Hearings Subcommittee
Public Transport Spine Study
Wellington Regional Transport Committee
Greater Wellington Regional Council
Te Pane Matua Taiao
Shed 39, Harbour Quays

WELLINGTON CITY'S PUBLIC TRANSPORT SPINE STUDY OPTIONS _ Oral submission

3.3 Spatial Accessibility Analysis Existing Pedestrian Infrastructure 400m without city parks

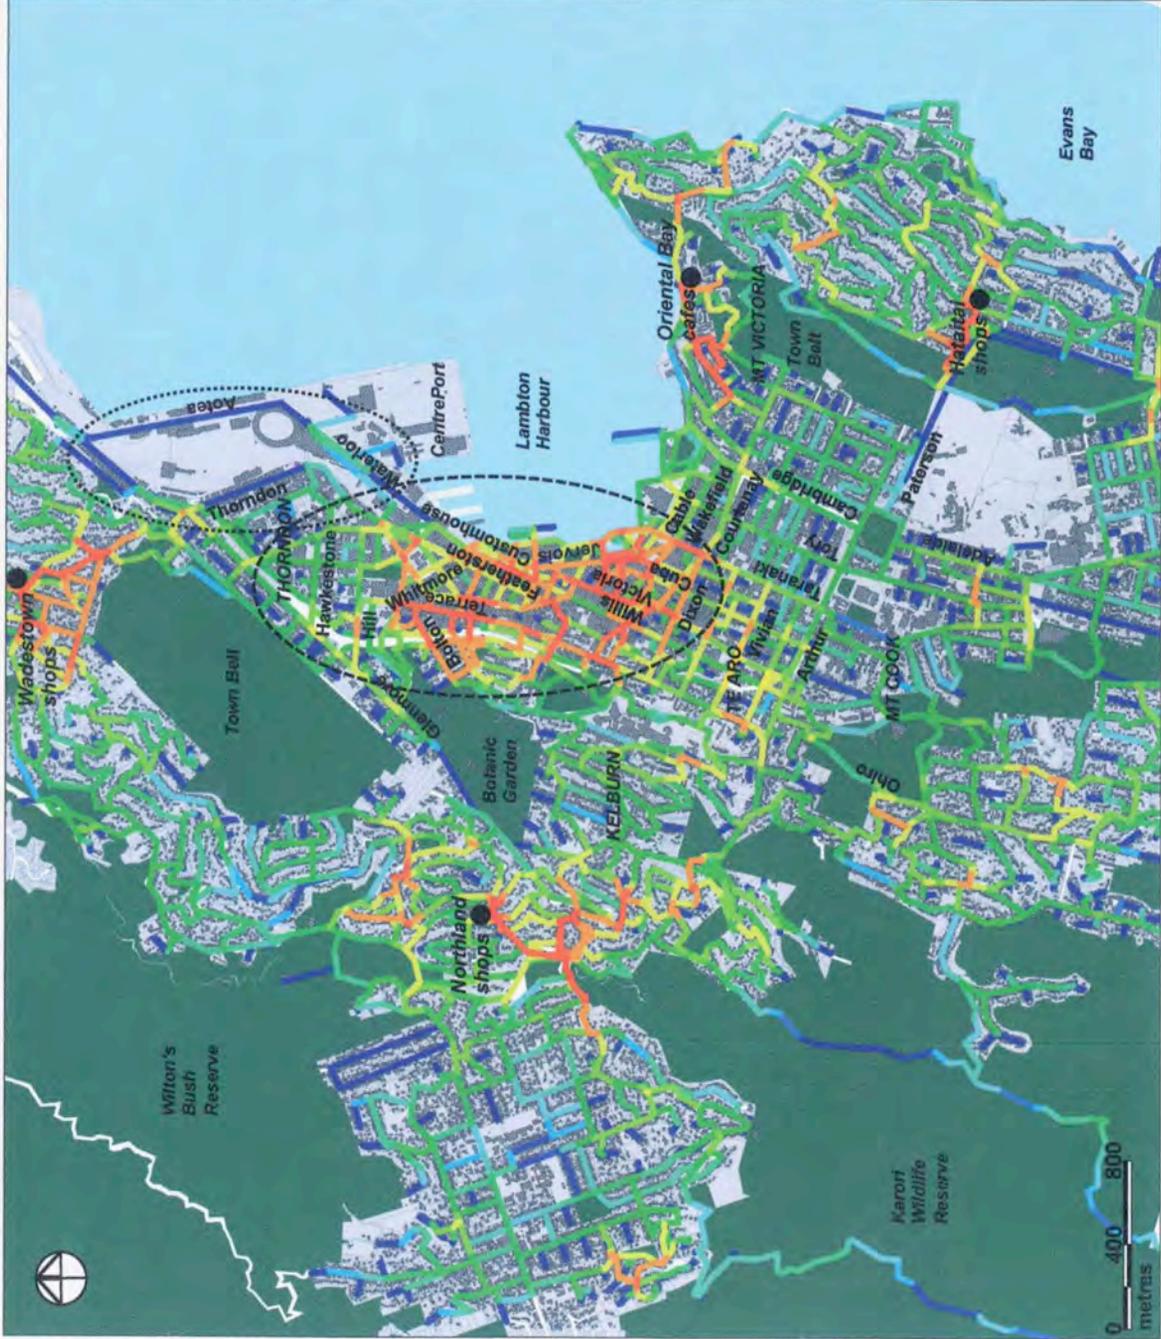
2. The investigation of the efficacy and accessibility of movement through the city by Space Syntax for the Wellington 2040 report, commissioned by Wellington City Council in 2011, demonstrates that the proposed PT infrastructure for the eastern spine is in the wrong place. I enclose key diagrams from Space Syntax's report to substantiate this claim. One of these shows that the strongest and most direct route for all vehicular traffic from the eastern suburbs to the central city is via the existing Hāitaitai bus tunnel, not the motorway on Ruahine Street (pg 35). Another diagram shows that Ruahine Street has poor accessibility and connectivity compared to the Hāitaitai suburban centre (pg 15). These diagrams, and this report, demonstrate that the existing bus tunnel must be a core part of any future transport network.
